PMOC REPORT

OP 32A – Project Transit Capacity Review
OP 32C – Project Scope Review
OP 32D – Project Delivery Method Review
OP 33 – Capital Cost Estimate Review
OP 34 – Project Schedule Review
OP 40 – Risk and Contingency Review

Honolulu High-Capacity Transit Corridor Project
City and County of Honolulu
Honolulu, HI

October 2011 (FINAL)

Figure 3. Peak Capacity Specifications and Peak Demand Forecasts

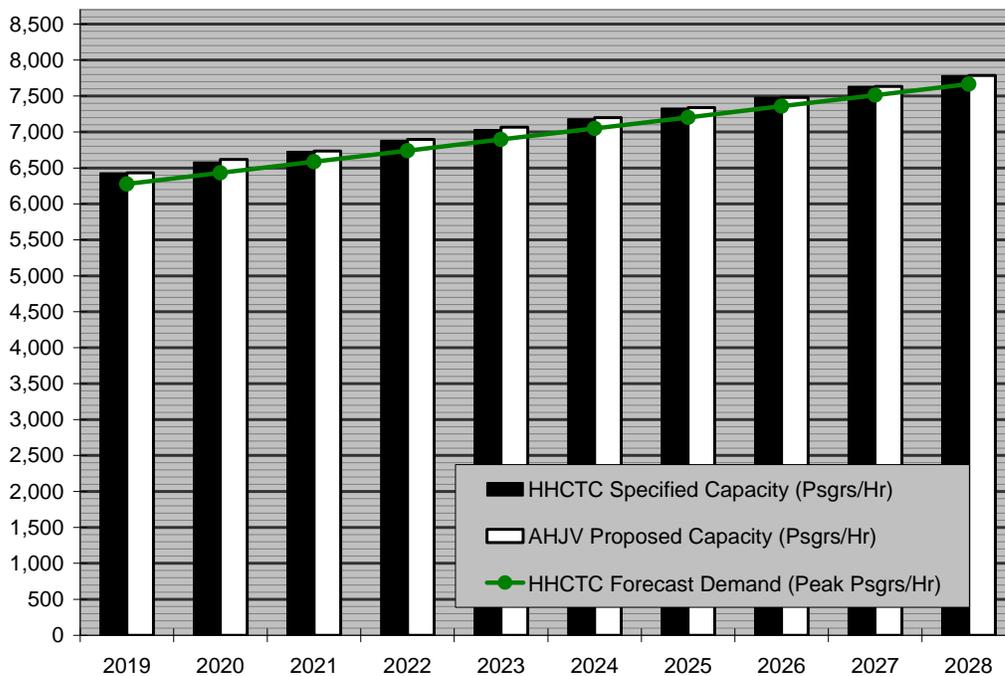
Inspection of Table 9 and Figure 3 shows that the grantee’s specified peak period hourly capacity closely tracks the forecast growth in peak hourly demand and that AHJV’s proposal for each year exceeds the grantee specification by a marginal increment of standing room.

Figure 6. Peak Capacity Specifications and Peak Demand Forecasts
with Peak 15 Minute Rate shown

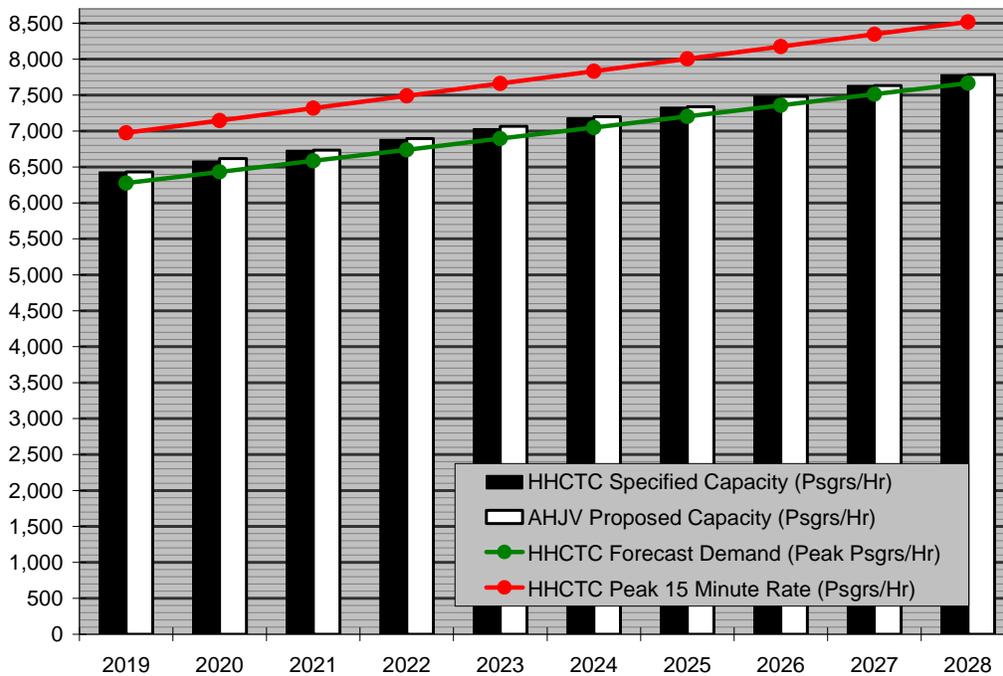
Figure 6 illustrates the gap between average hourly peak flows and the ridership that would be expected if passengers arrived at a rate 3% higher than the typical peak hour forecast during any rush hour period.

The overall effect of this approach is forecast to adversely affect the comfort of some peak passengers, but, since the desired level of crowding set by grantee is relatively generous, the system should still be able to physically carry all forecast passengers in each year of forecast operation.

Figure 15. Thousands of Infrastructure Maintenance Hours per Route Mile

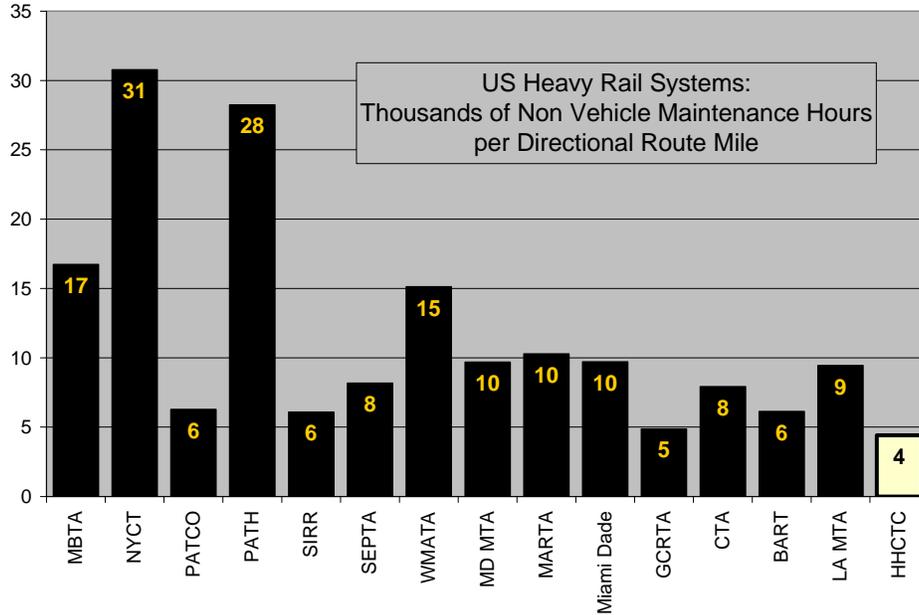
Figure 15 illustrates how AHJV’s infrastructure staffing plans call for it to be the most parsimonious of all US rapid transit operations. This may be unrealistic in the long run,

The PMOC suggests that the grantee may wish to review infrastructure maintenance staffing assumptions with AHJV to ensure that expectations are realistically aligned with service availability and customer service goals.

Figure 16. Thousands of Infrastructure Maintenance Hours per Track Mile

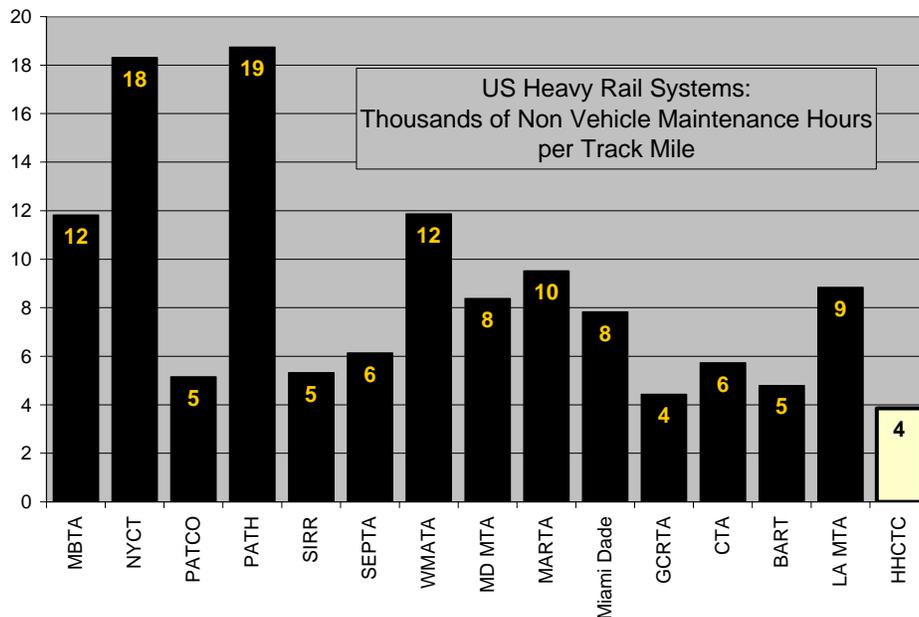
Figure 16 reinforces the suspicion that AHJV and the grantee may be underestimating the maintenance workload required to sustain the system infrastructure and operation.

Figure 28. Calendar Library

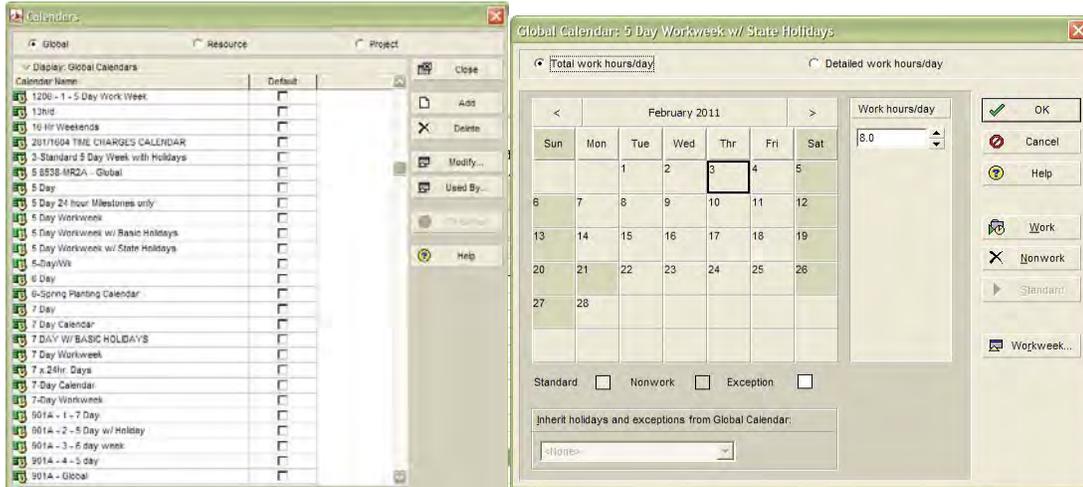
The calendar library does not contain anticipated inclement weather days. These periods of non-work performance can be addressed in many ways, such as by increasing activity durations or accounting for them in separate calendars. The grantee did state that it incorporated latent contingency into the activity original durations, but not the calendars, to account for inclement weather. The grantee also stated that Hawaii, in general, does not encounter a significant amount of severe weather or undergo significant seasonal conditions that would negatively impact construction work activity.

Figure 35. Project Duration Cruciality with Risk Impacts

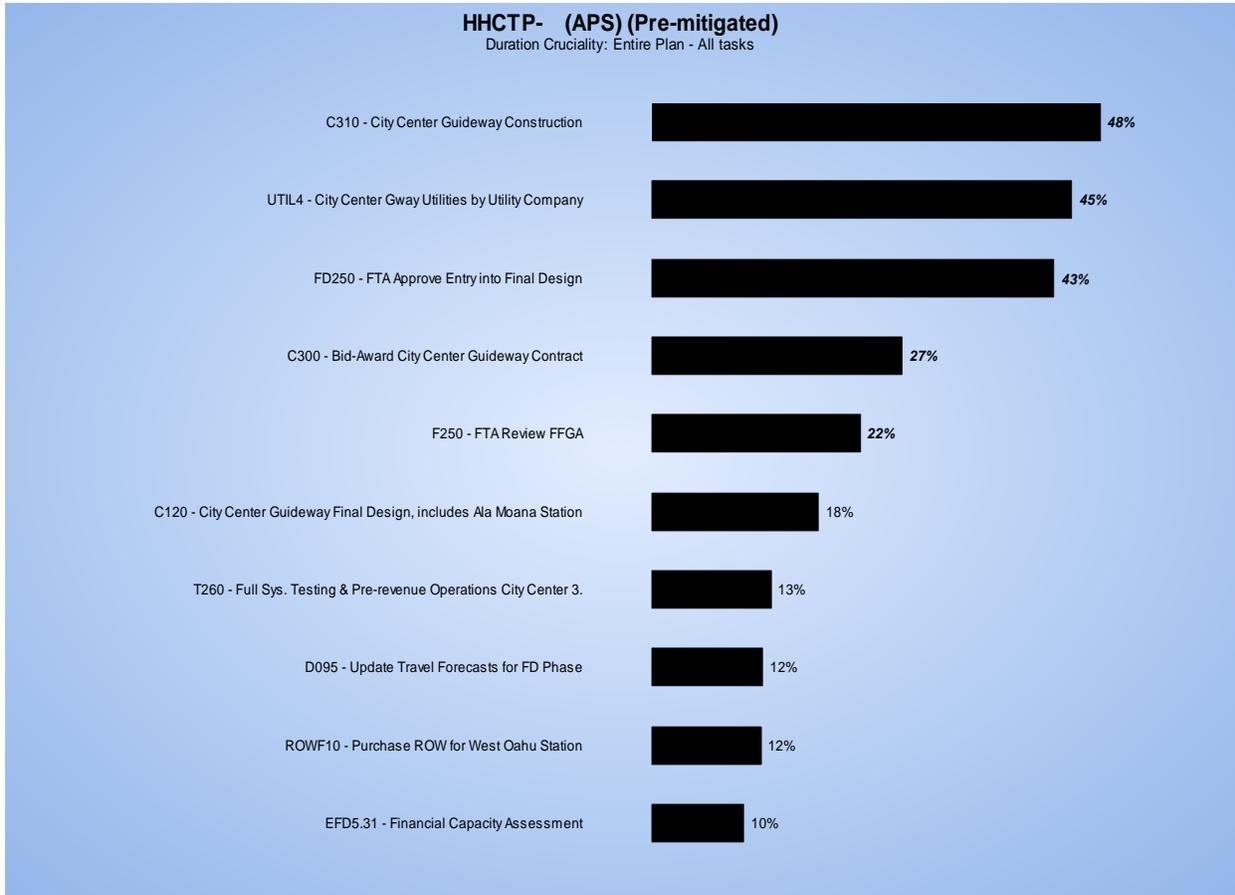
The grantee should concentrate on the activities contained in the duration cruciality tornado diagram and related critical path items during risk mitigation and monitoring.
